# SPECIFICATION

**MFG: CHANCE RIDES, INC.**  
**NAME: SKY DIVER**  
**TYPE: NON-KIDDIE**

# SKY DIVER

**ILLUSTRATION A**

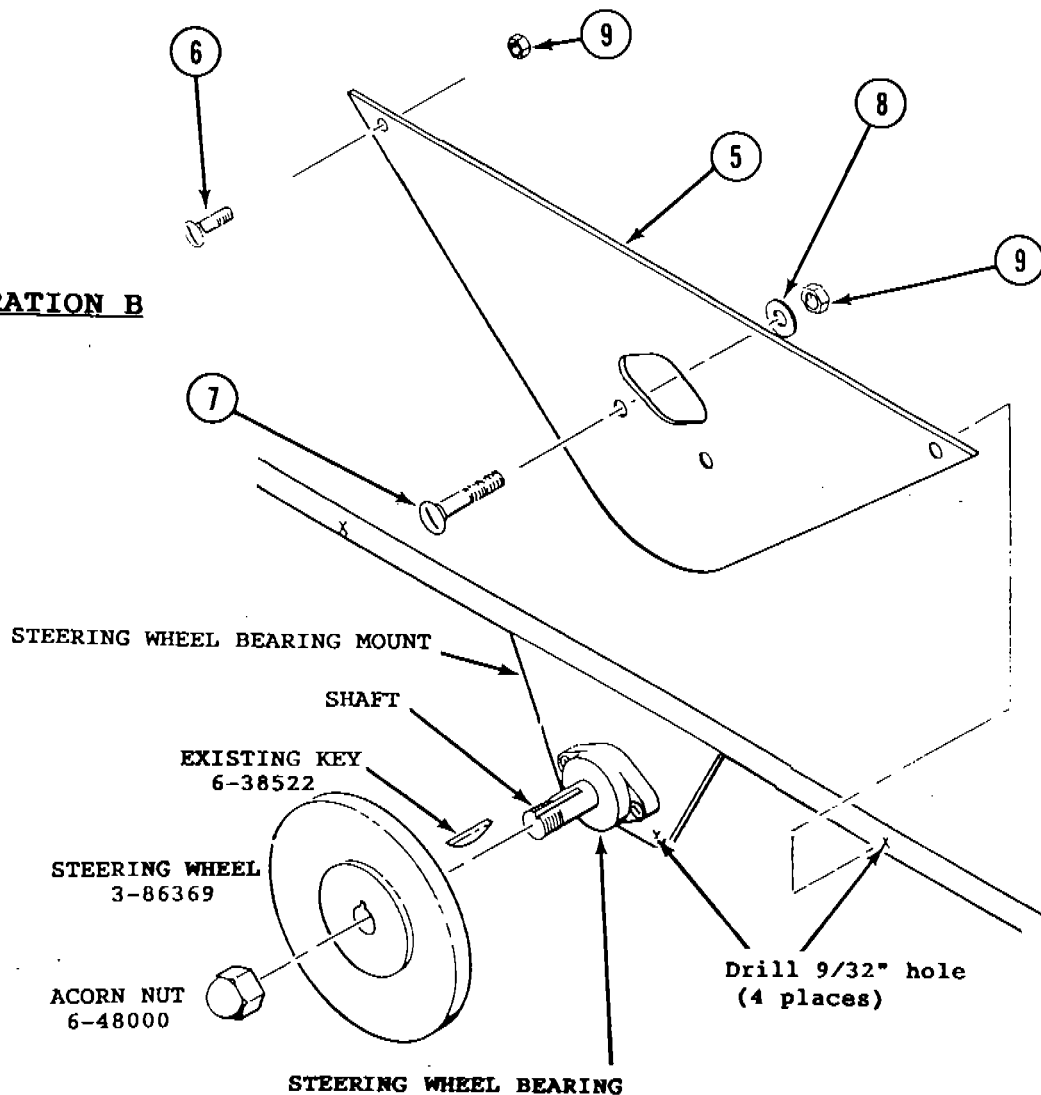
A modification kit has been developed to increase the clearance between the steering wheel and the grab rail, reducing the possibility of injuries due to pinched hands and/or fingers. Additionally, a guard plate installed behind the steering wheel eliminates a potential pinch point at the steering wheel bearing mount.

1. With vehicle hatch in the open position, remove and discard the existing grab rail (Illustration A) and fasteners. Do not install the new grab rail at this time.
2. Remove the steering wheel from the shaft (Illustration B). Save the acorn nut and key.
3. Place the guard plate (Item #5) over the steering wheel bearing. Use the plate as a pattern to locate and drill mounting holes. See Illustration B for hole sizes and locations.
4. Install the guard plate using the fasteners provided (Items #6, #7, #8 and #9).
5. Install the steering wheel using the existing key and acorn nut. The acorn nut should be secured with a liquid locking material.
6. Install the new grab rail (Item #1) using the fasteners provided (Items #2, #3 and #4). Install the capscrews going down through grab rail.

Order kit number K108R1052-0, which includes the parts necessary to modify one ride. Install the parts using the instructions provided on the following pages of this bulletin. Fill out the attached Certification Of Compliance for the modification within 15 days of receipt of the kit.

## Latch Engaged In Slot In A-Frame

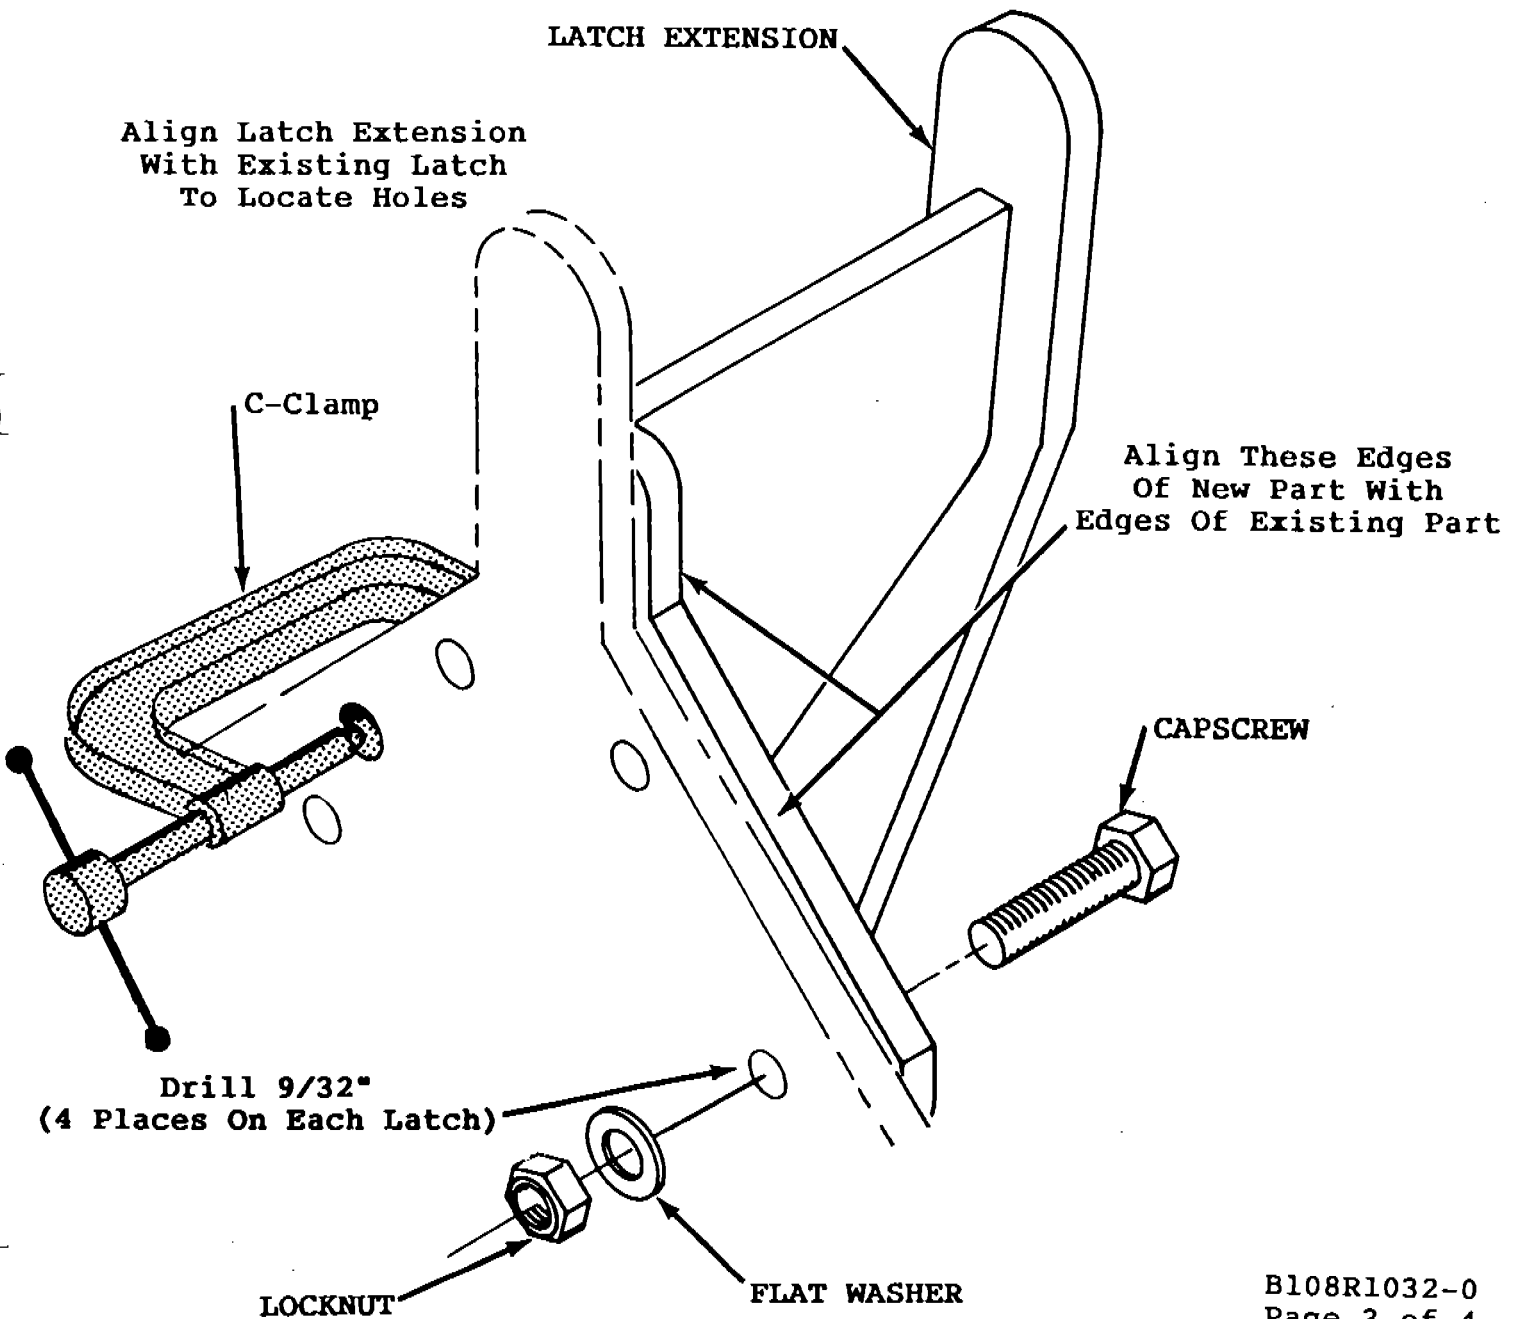
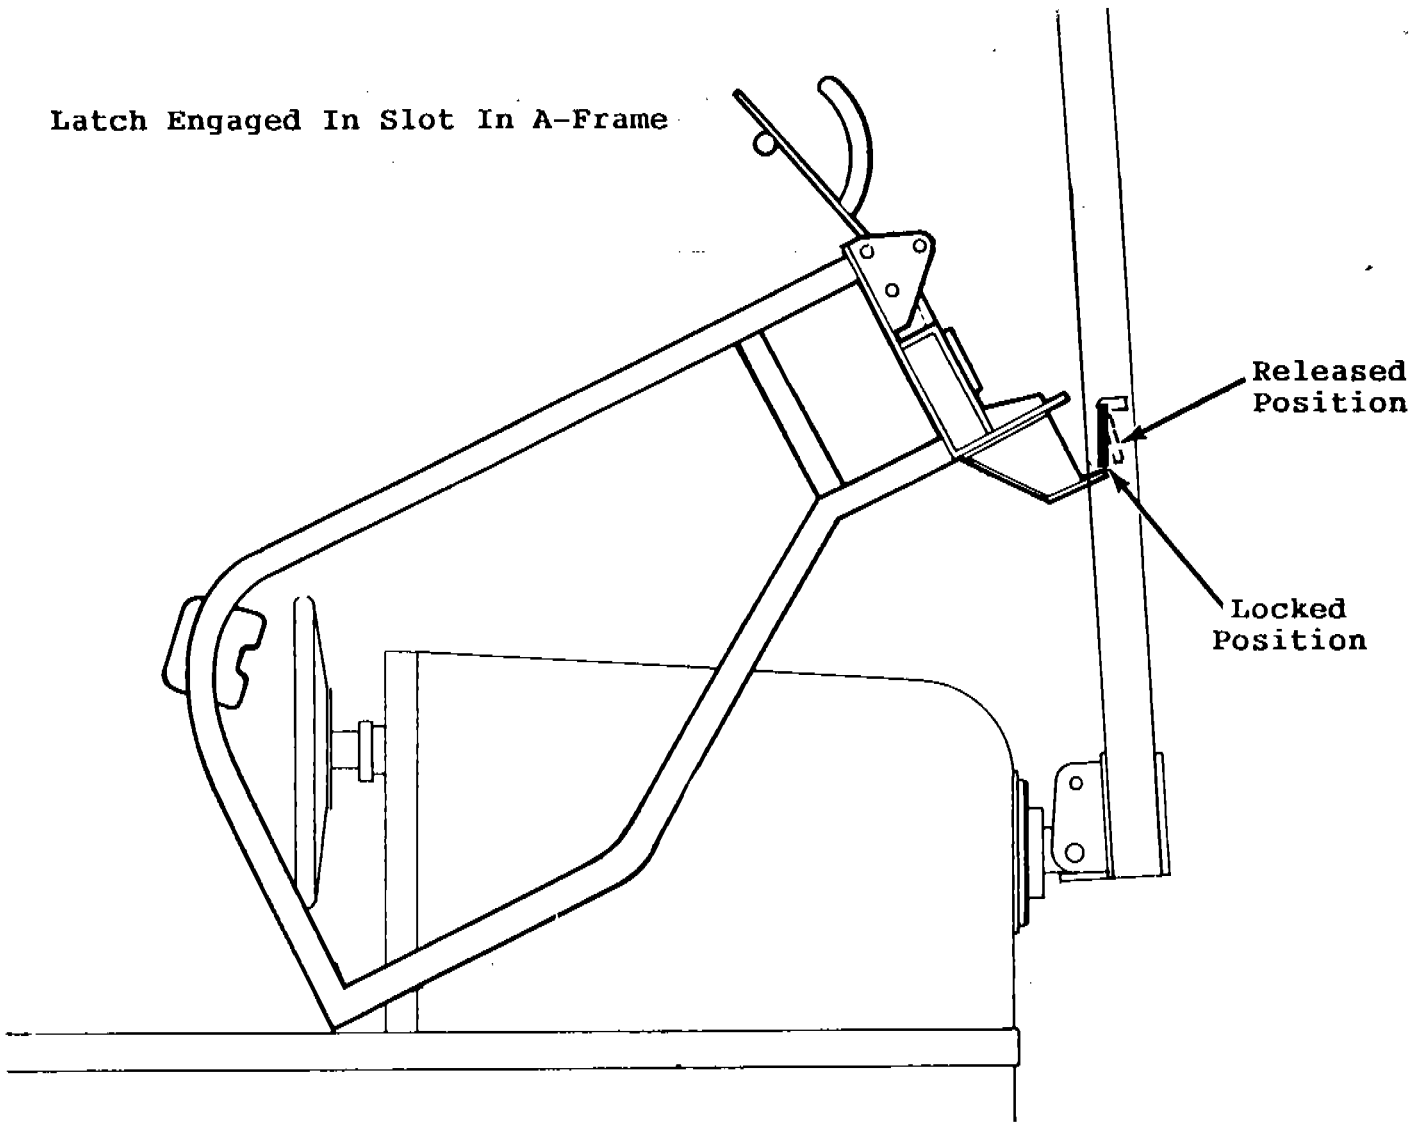
A modification kit has been developed to increase the clearance between the lap bar and the control wheel, reducing the possibility of injuries due to pinched hands and/or fingers.

1. Align the edges of latch extension (Item #1) with the edges of the existing latch as shown in the illustration below.
2. Use a C-clamp to hold the latch extension in place as shown.

3. Rotate the hatch to the open position as shown and check to make sure that:

- The latch securely engages in the A-frame slot for loading and unloading (Locked Position).
- The latch will release properly when the latch release is disengaged (Released Position).

**NOTE:** If necessary, adjust the latch extension position slightly to obtain the correct engagement into the A-frame slot. Also, the tang of the latch extension can be ground shorter to allow the correct release from the latch.

TIE DOWN CABLE  
(CUSTOMER FURNISHED)

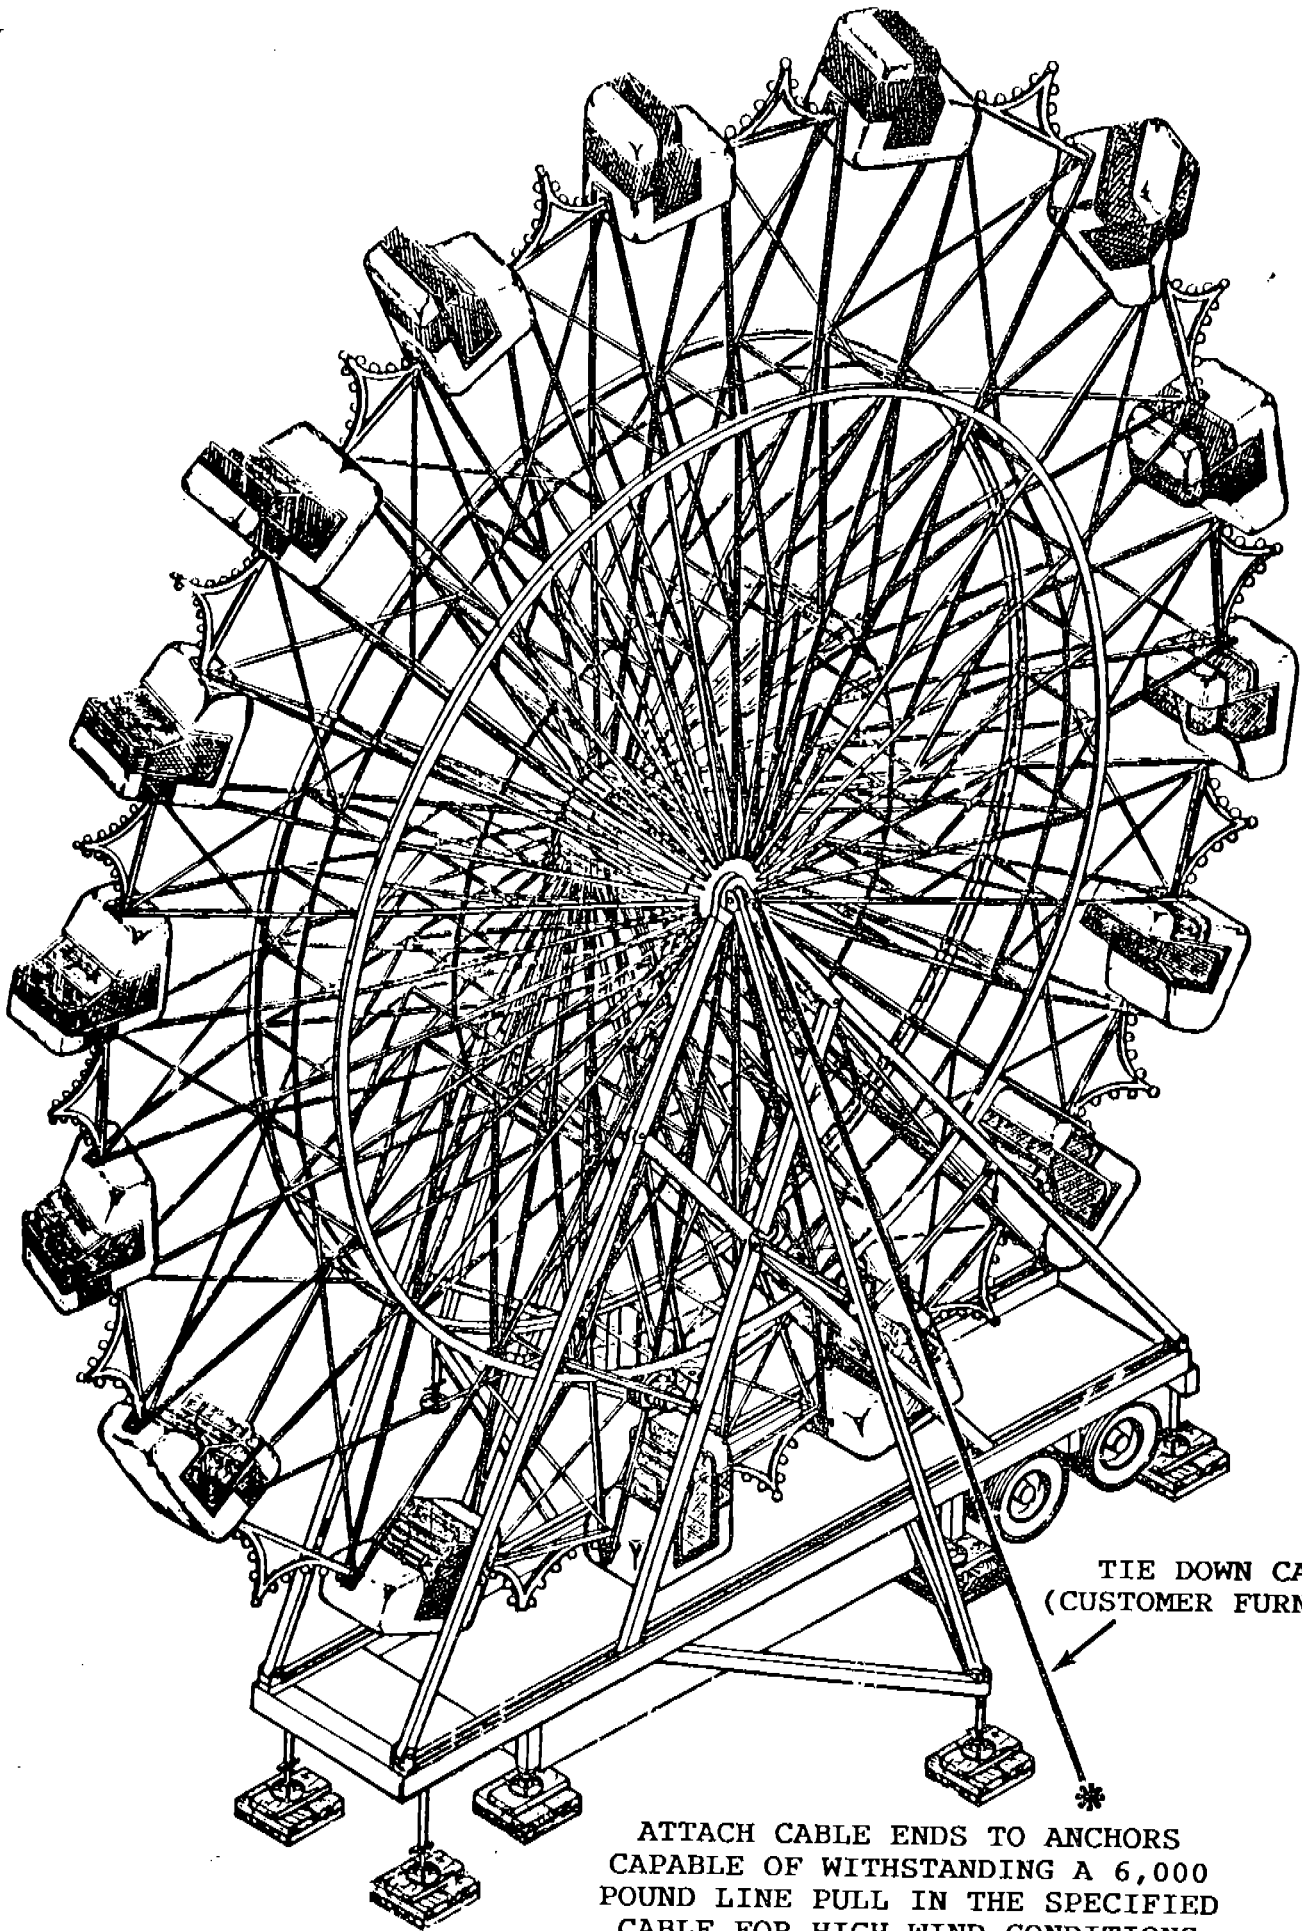
The modification consists of welding links to the ride towers, to be used as anchors for tie-down cables if required by wind conditions. After the modification is performed, always follow the recommended blocking and tie-down procedures.

1. Attach cables to the pear links on the tower legs. Attach the other end of each cable to anchors capable of withstanding a 6,000 pound line pull in the specified cable. (See illustration on next page).
2. Tighten the cables until snug.

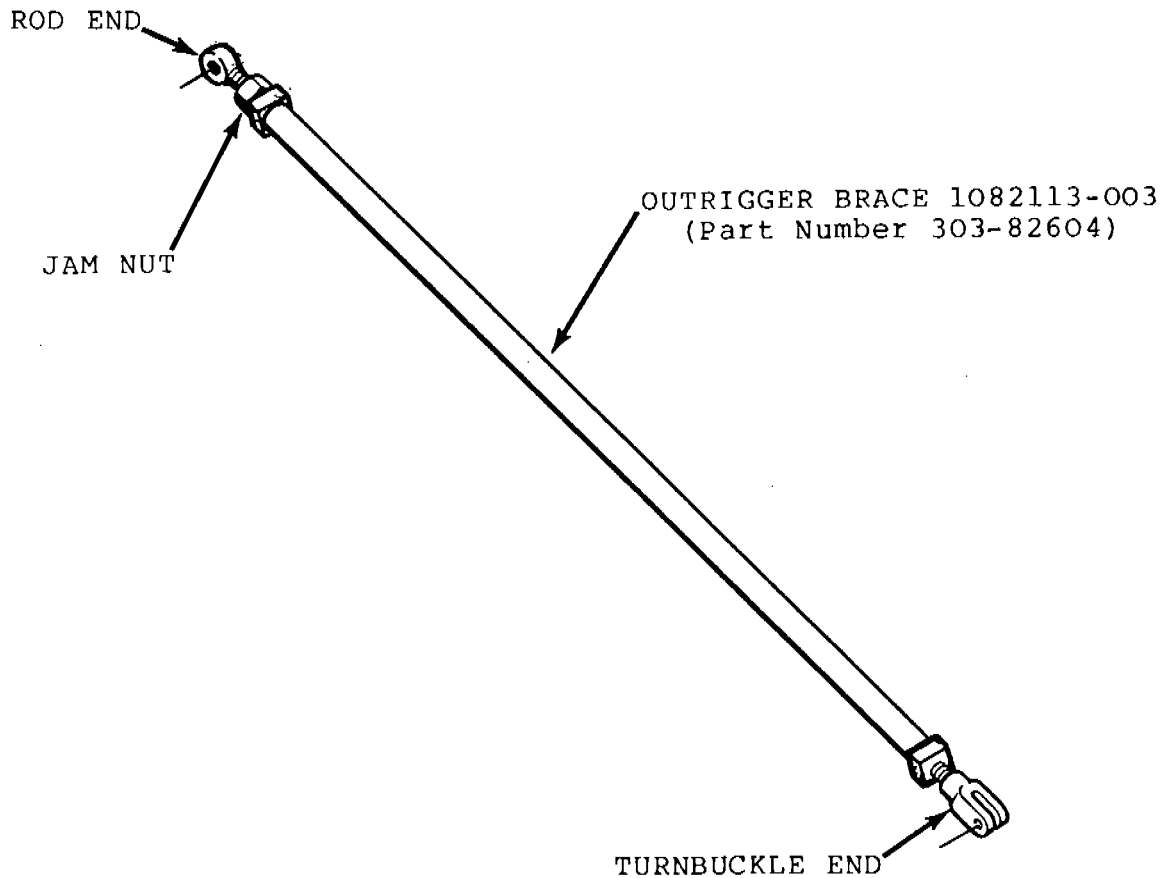
CHANCE RIDES, INC. has developed a rigid brace to replace the existing bar and turnbuckle brace on the new style outrigger supports on SKY DIVERS and ASTRO WHEELS. This rigid brace will further increase the stability of the outriggers.

1. Remove the bar and turnbuckle assembly from one side of the ride.
2. Install the new outrigger brace using the existing hardware.
